September 1, 2011

**Re: Notice of Violation
Circleville First Moving Forward Church, Pickaway County**

Circleville Moving Forward Church
Stabilize barren areas
Scioto River Watershed
August 26, 2011
Photo by: Greg Sanders

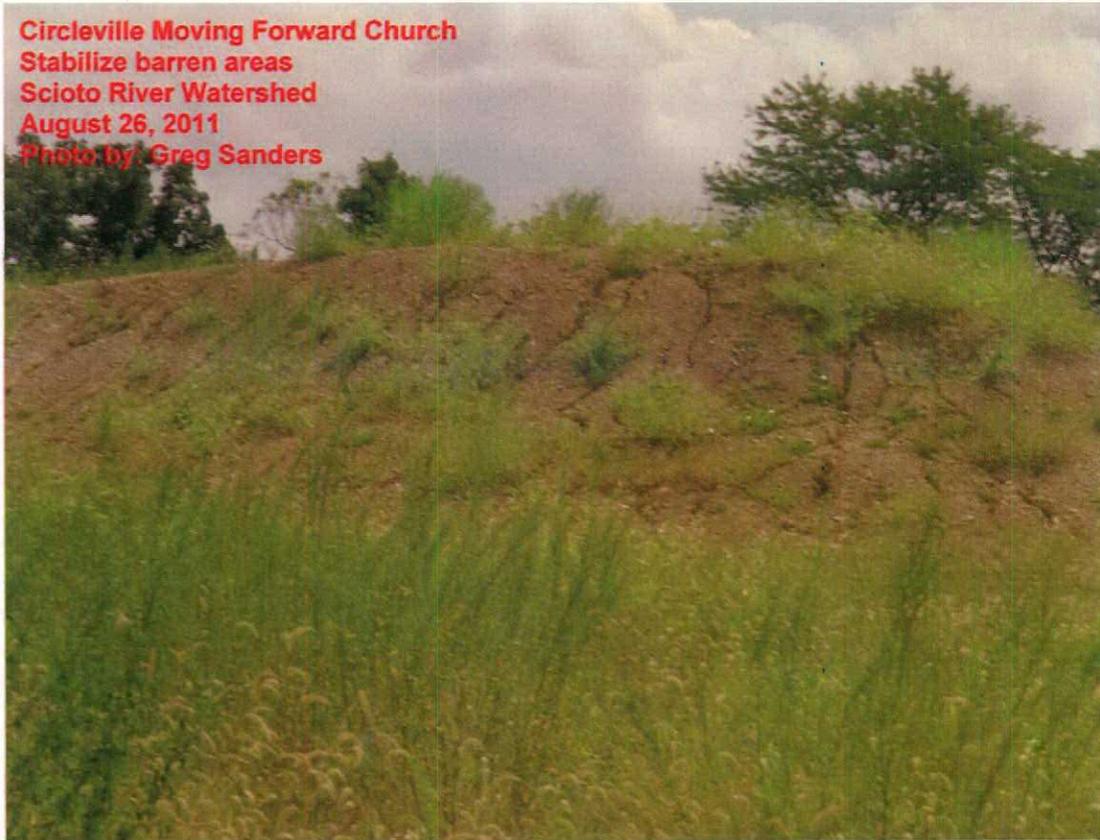
1. The rear of the site including the stockpile was still barren. There was a limited amount of silt fence installed to prevent erosion of sediment from the site. There are large rills and gullies forming which further allow the site to erode. Please install and maintain erosion controls and stabilize the barren areas. Please see attached pictures.
2. As stated previously, please install rock, straw bales and silt fence as check dams in the ditch along the walking trail. This will slow the velocity of the storm water. If the check dams and silt fence do not adequately contain the storm water, then it is recommended to utilize a berm to direct the sediment-laden storm water to the sediment pond. Please see attached pictures.

Circleville Moving Forward Church
Maintain erosion controls
Stabilize barren areas
Scioto River Watershed
August 26, 2011
Photo by: Greg Sanders
